Enclosed is the response to your Notice of Deficiency for Operable Unit 1085.

**List of Deficiencies
Los Alamos National Laboratory
Operable Unit 1085**

Response to NOD for RFI Work Plan for OU 1085

Figure 5-11. Sampling locations in Aggregate 5—TA-14: Septic Tank.

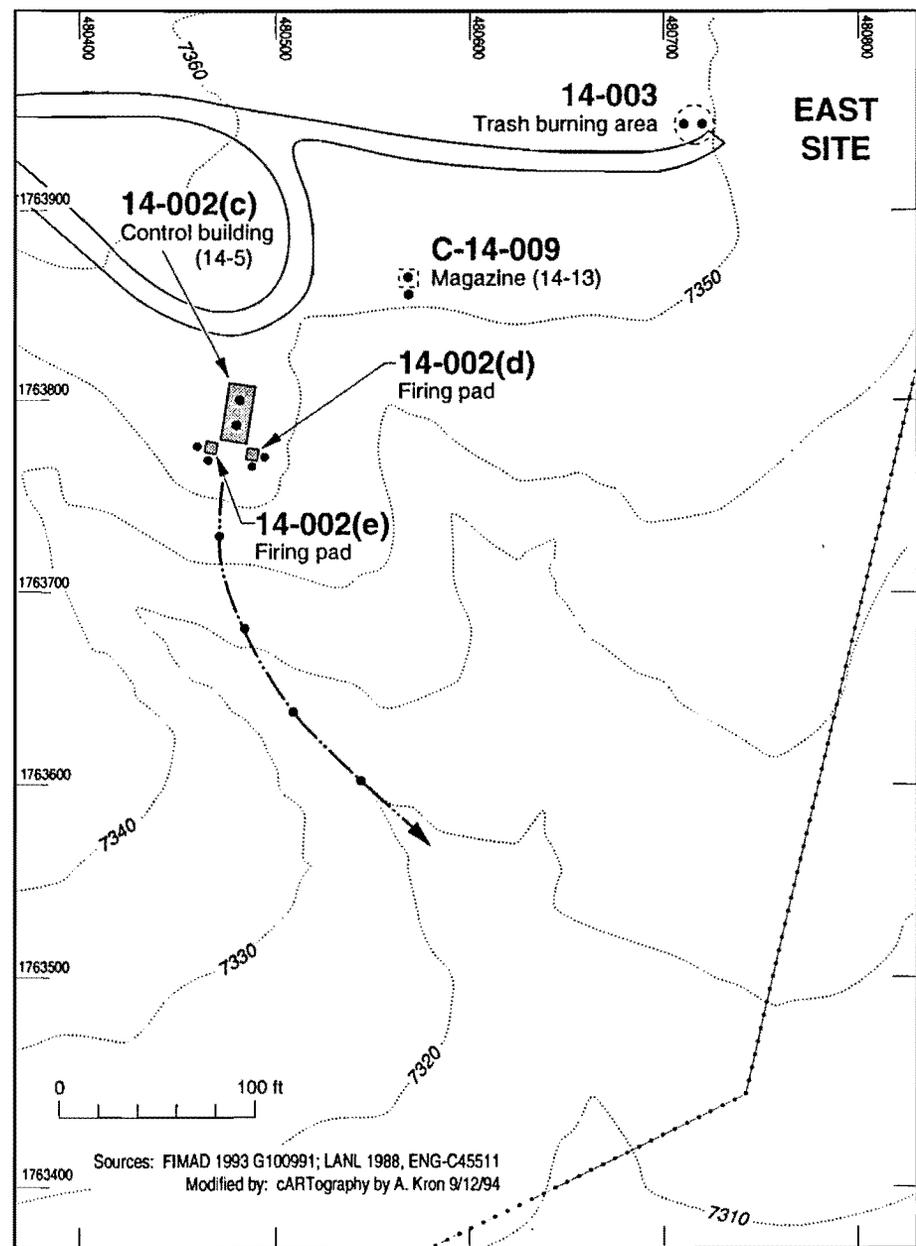
11. **5.5.6.3 Sampling Summary, p. 5-5-8 - A deeper sample should be collected immediately below the outfall at 18 - 24 inches and analyzed as the other samples.**

Response: LANL will sample immediately below the outfall at 18–24” depth, and analyzed for HEs and HE degradation products, metals, U, cyanides, and semivolatiles (see attached revised Figure 5-11 and Table 5-14).

Figure 5-13. Sampling locations for Aggregate 6—TA-14: East Site and West Magazine.

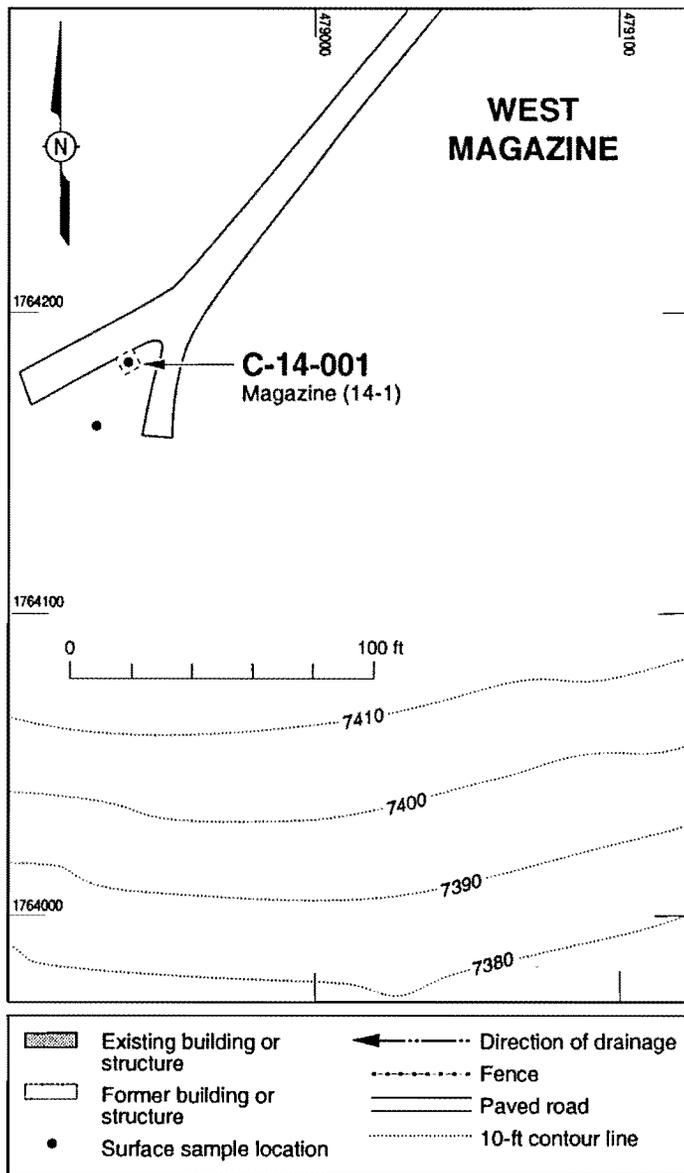
- a. **SWMU 14-002(C) - It is unclear why LANL believes that contamination has escaped from this bunker. It is more likely that contamination found outside the bunker is a result of activities at SWMUs 14-002(d and e).**

- b. **East Site Drainage Sampling, p. 5.6-15 - The four sampling locations are not indicated on any figure in this section. LANL shall provide a figure showing the location of the drainage and the sampling locations.**

Response: There is no evidence to suggest that contamination has escaped the interior of the bunker, 14-002(c). Contamination on the bunker exterior would most likely arise from explosive events at 14-002(d,e); however such contamination would probably be small given that concrete slabs were placed between the firing pads and the bunker to deflect the blast. We propose to alter the sampling plan for 14-002(c) and limit the sampling to two interior soil samples (field-screened for HEs and U, and analyzed for RCRA metals, U, HEs, and HE degradation products). Revised Figure 5-13 and Table 5-17 (attached) indicate the modified sampling for 14-002(c).

Response: Revised figure 5-13 (attached) show the drainages and sampling locations for SWMUs 14-002 (c,d,e).
